**World Forum for Harmonization of Vehicle Regulations****Working Party on Passive Safety****Fifty-seventh session**

**Regulation No. 94 (Frontal collision)****Proposal for 03 series of amendments to Regulation No. 94  
(Frontal collision)****Submitted by the expert from France as Chair of the Informal Working  
Group on Frontal Impact\***

Model B

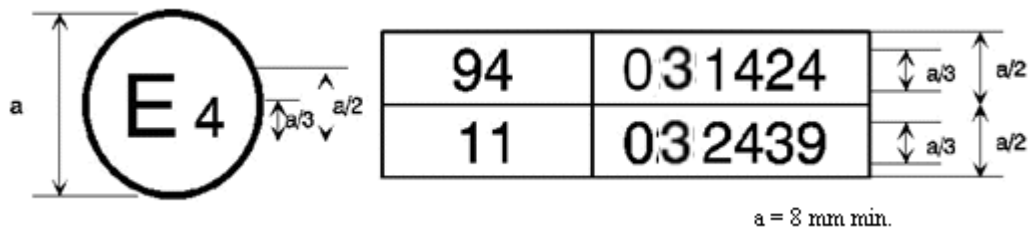
The above approval mark affixed to a vehicle shows that the vehicle type concerned has been approved in the Netherlands (E 4) pursuant to Regulations Nos. 94 and 11<sup>+</sup>. The first two digits of the approval numbers indicate that, at the dates when the respective approvals were granted, Regulation No. 94 incorporated the 02 03 series of amendments and Regulation No. 11 incorporated the 02 03 series of amendments."
